ADDENDUM NO. 7

Project Name: Sandridge Golf Club New Clubhouse

ITB Number: 2024029

MECHANICAL CONTROLS

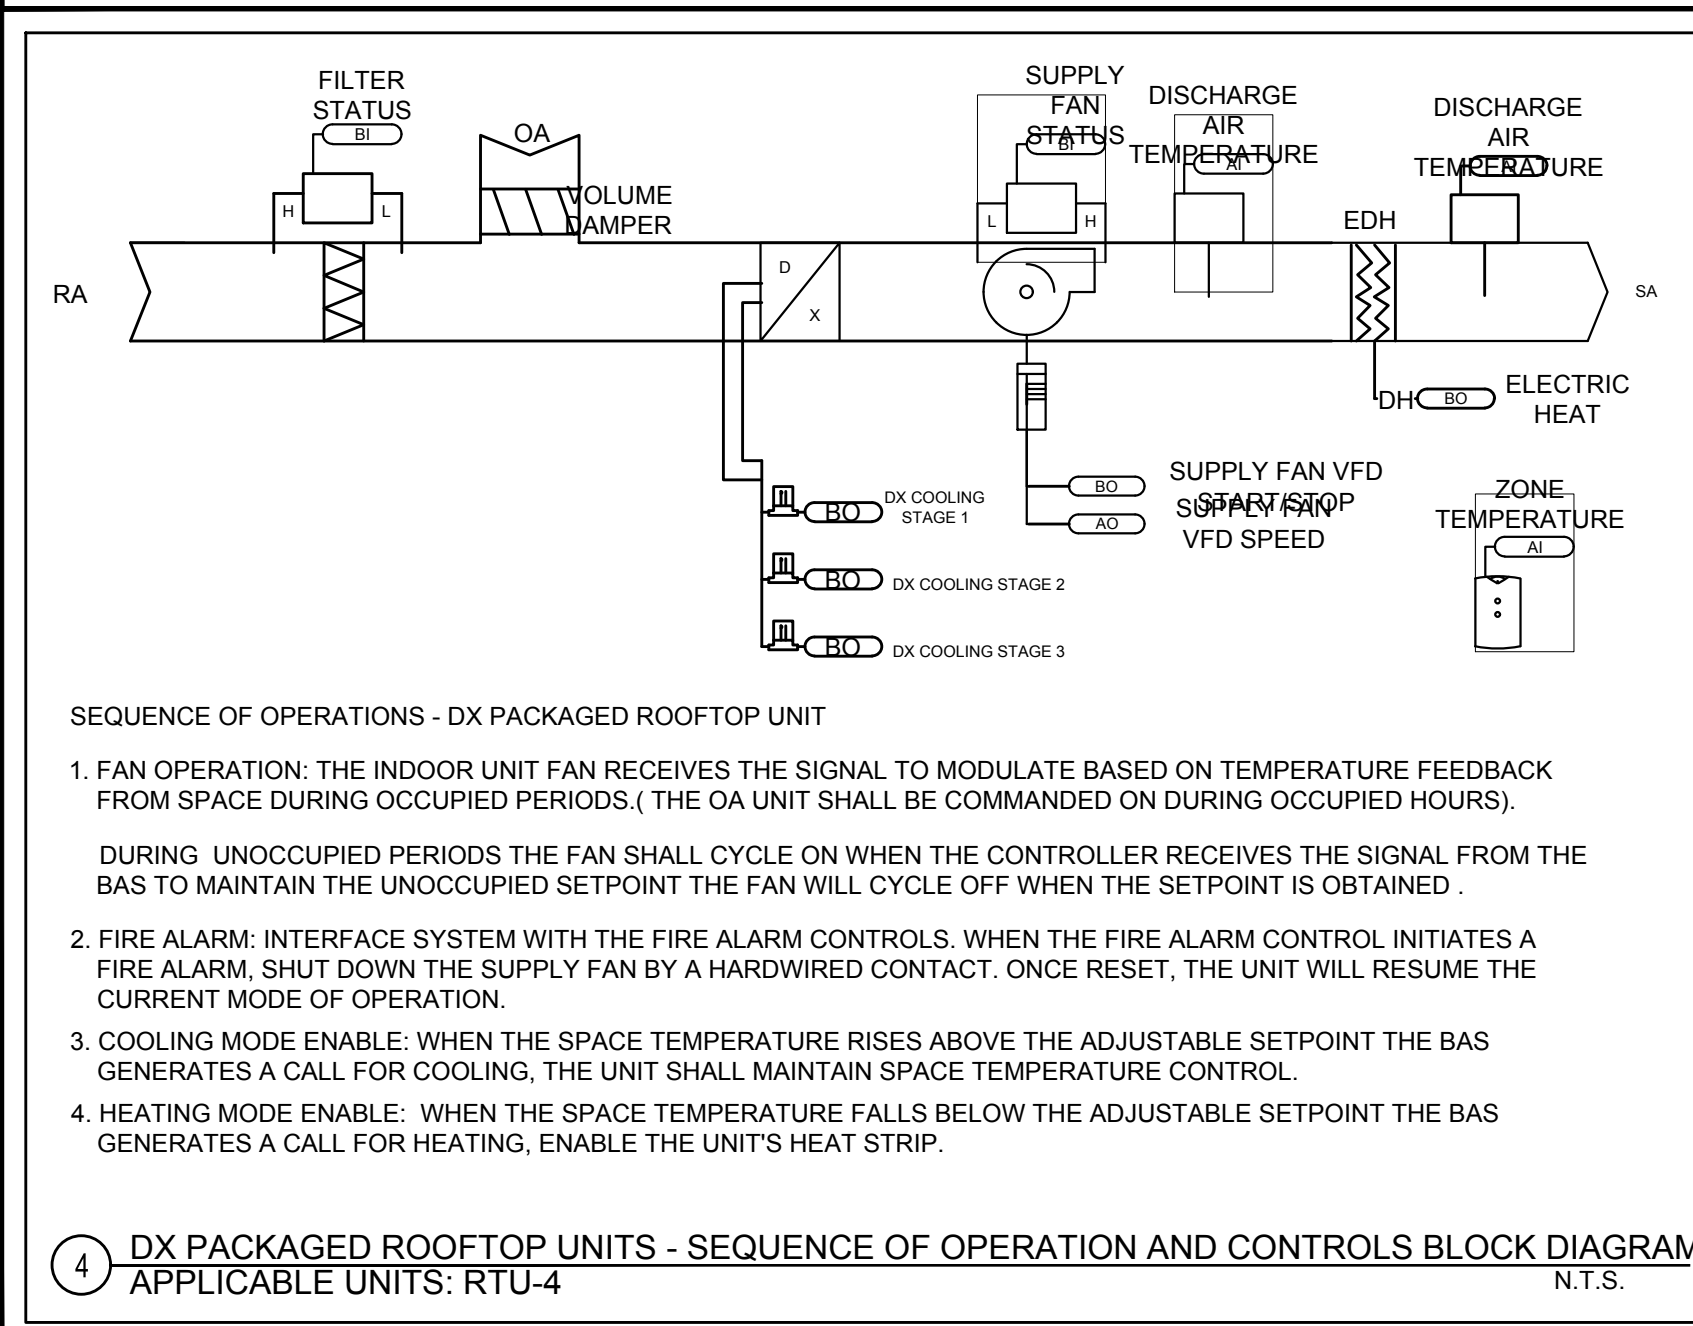
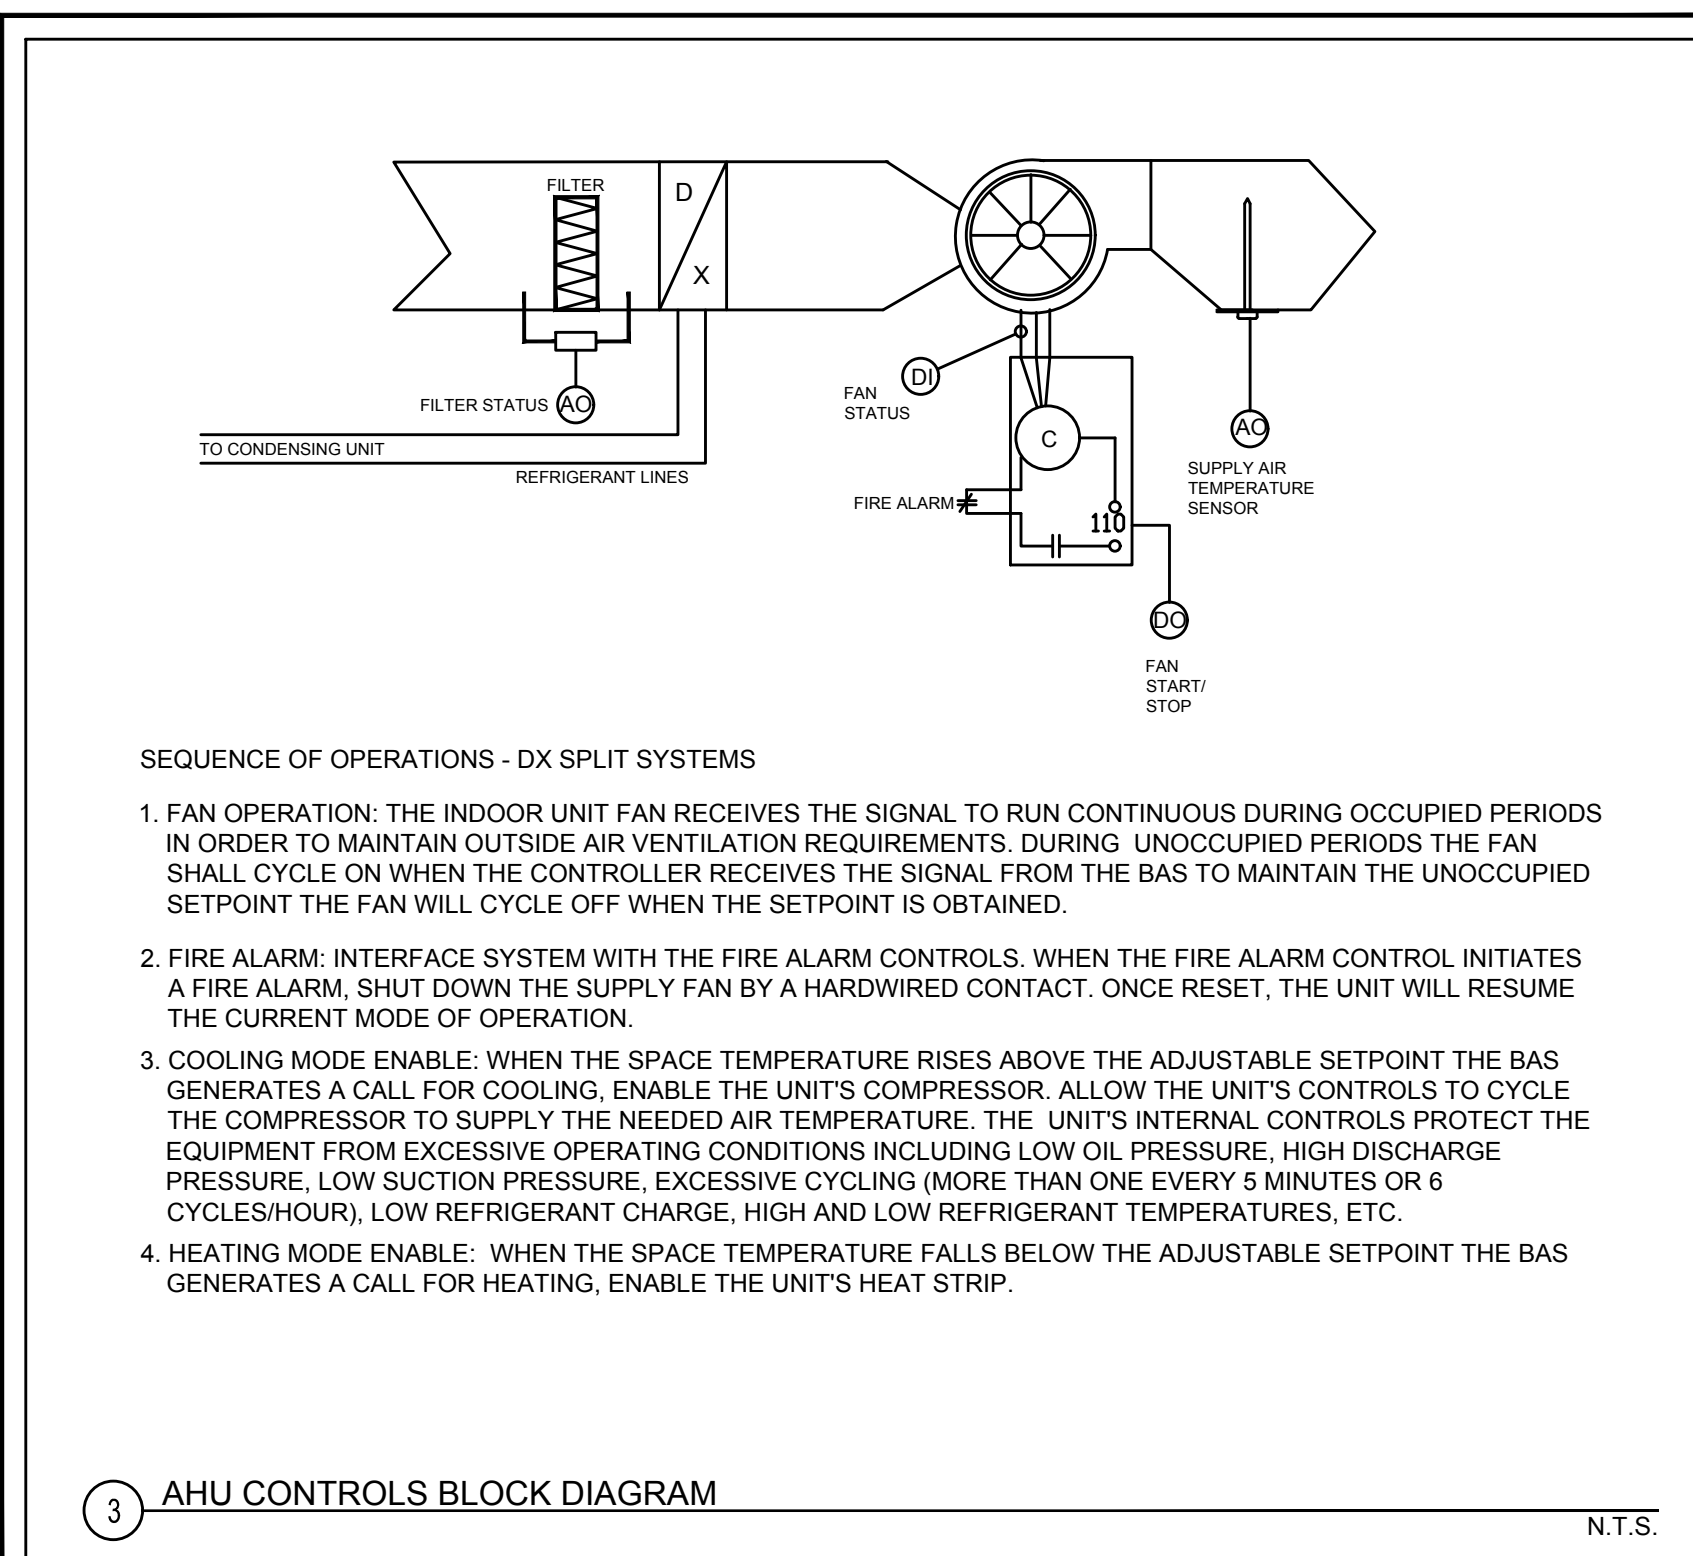
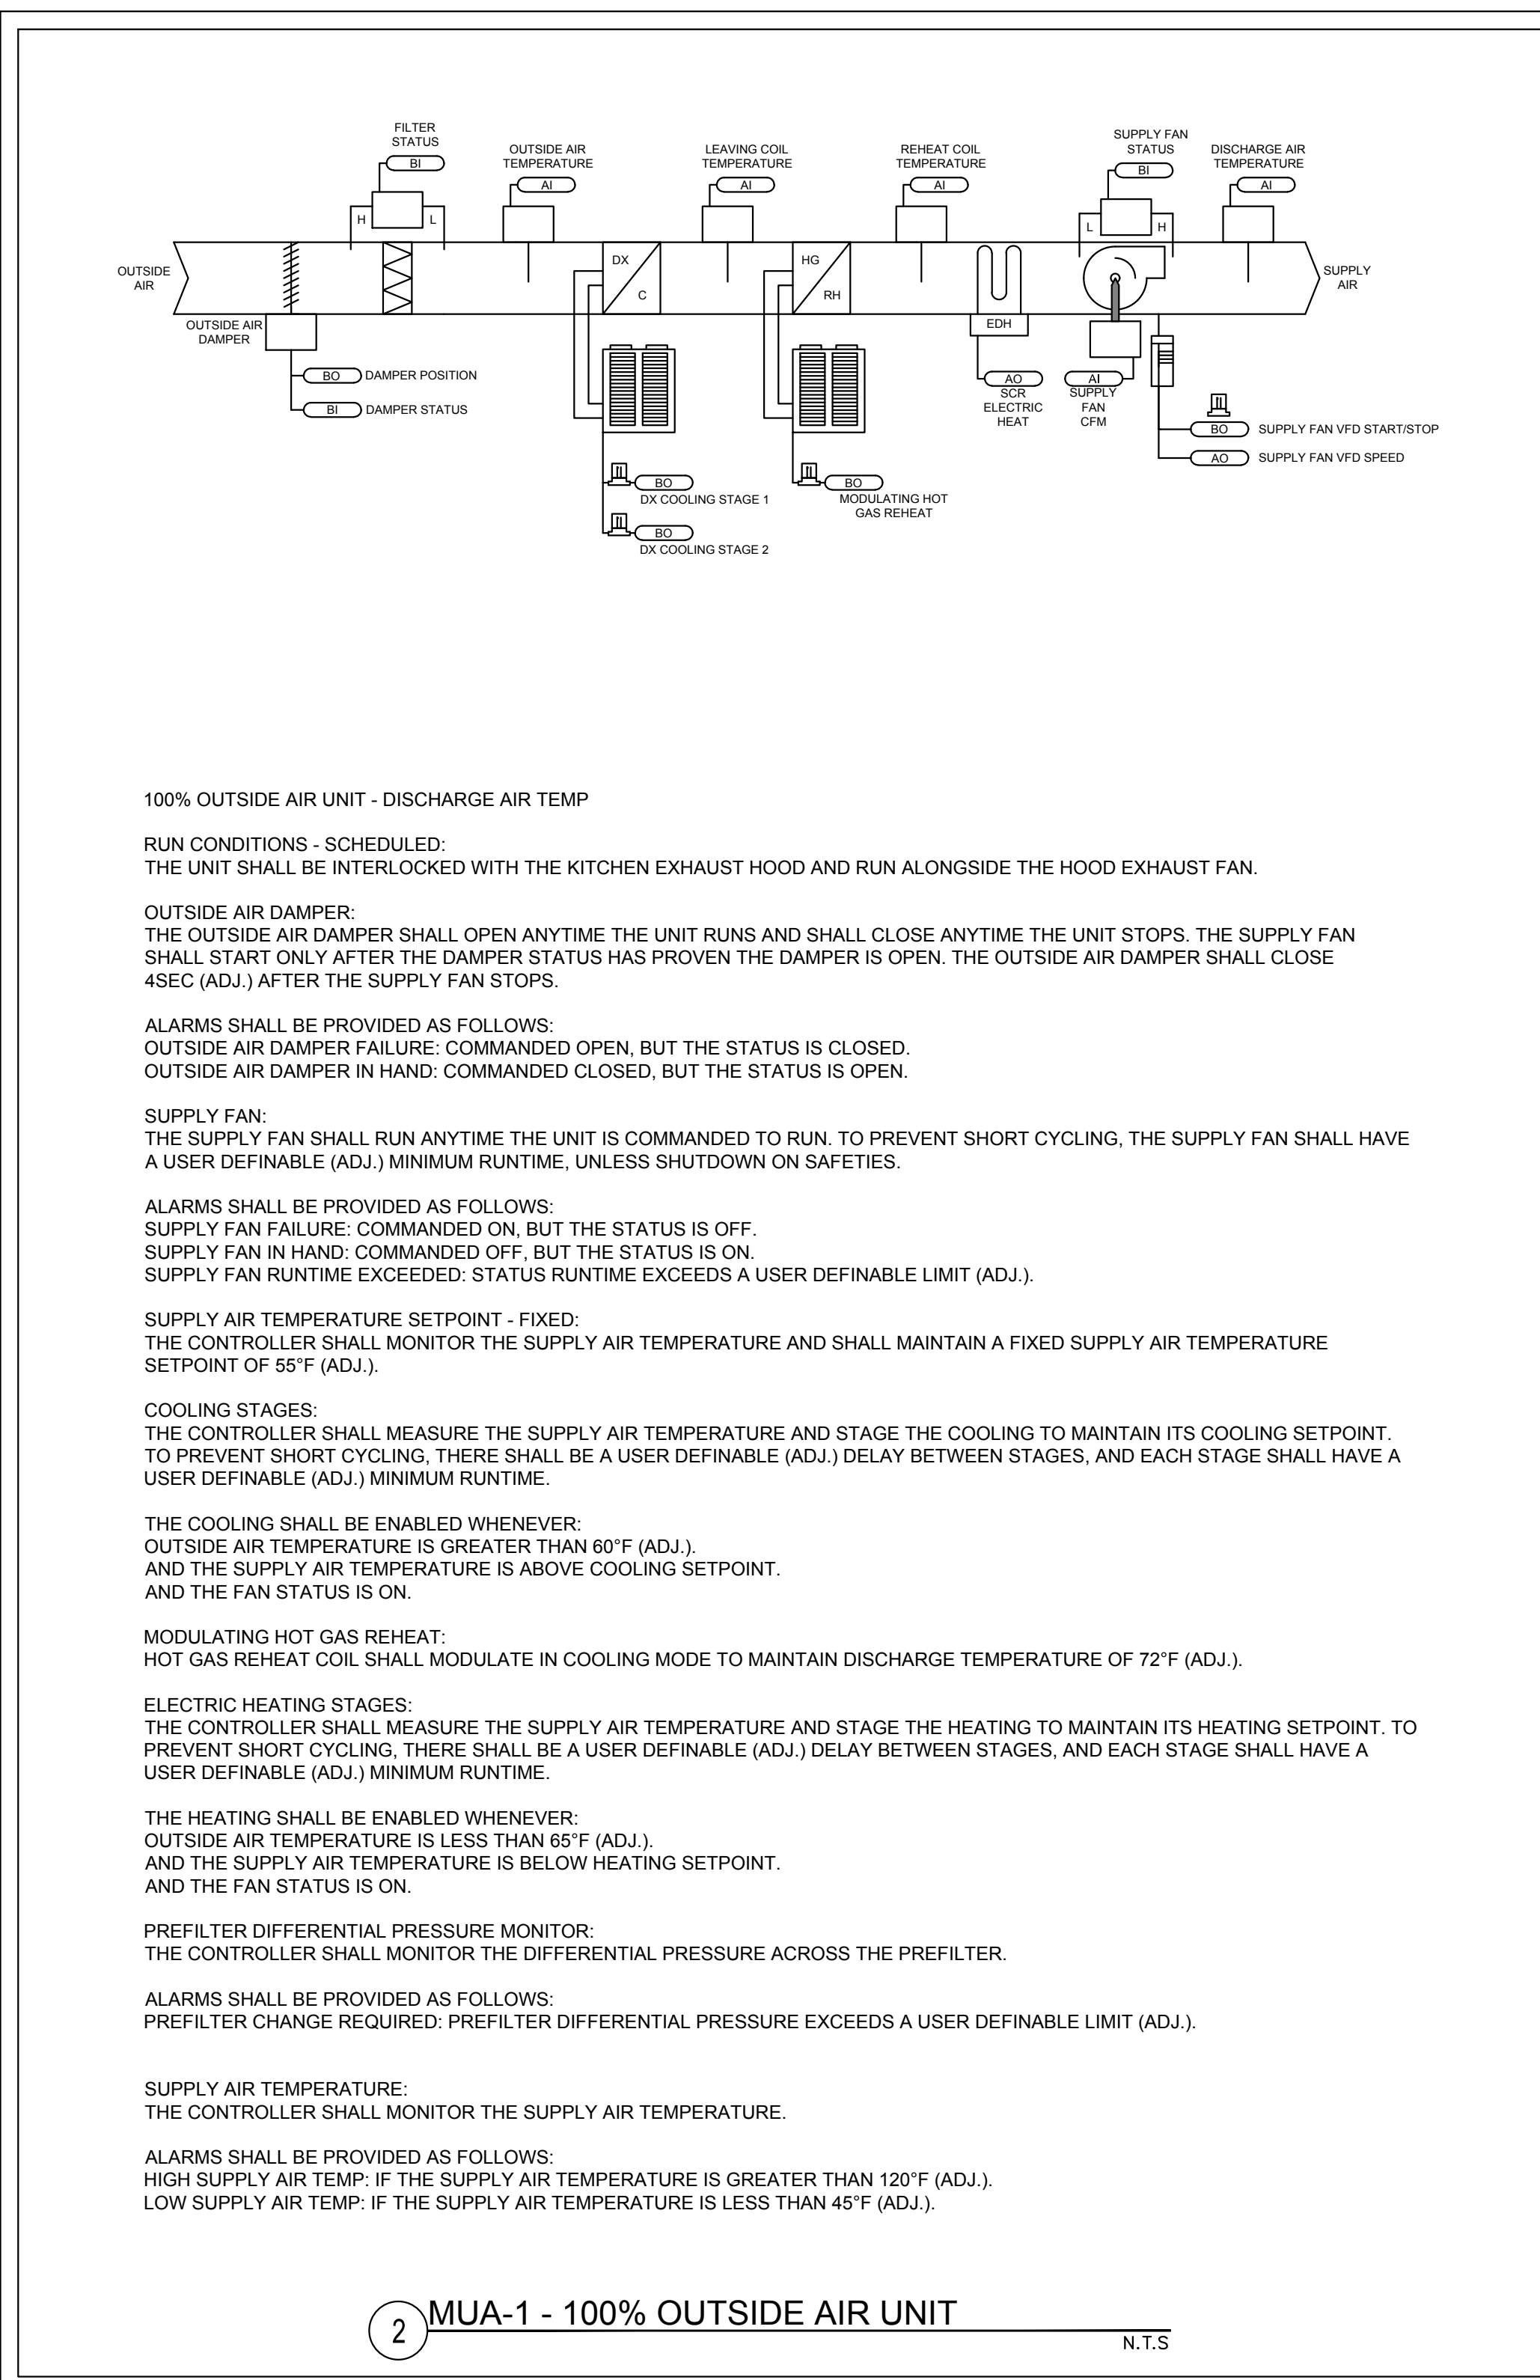
Response: Note #17 is a generic thermostat spec and has been removed for clarity
- M000 Note #20 Indicates Fully Integrated Owner/ Building Control System BMS/EMS. With interface gateways. The plans read like a standalone system, There are no control sequence plans.

5. Section 230000 Item 15 calls out controls and wiring.

6. Section 3.11 States see control drawings for control sequence. Where do I find these drawings?

Response: The building is intended to have a BMS system. Control Plans have been added to Sheet M501.
- Are you looking for a Trane tracer system with Building automation (BAS) with graphics as this also requires additional Electrical work and LAN Drops.

Response: Section 23000 was eliminated in addendum # 2. Controls sheet M501 has been added to the drawings.

Response: Controls Sheet M501 has been added to the drawings.
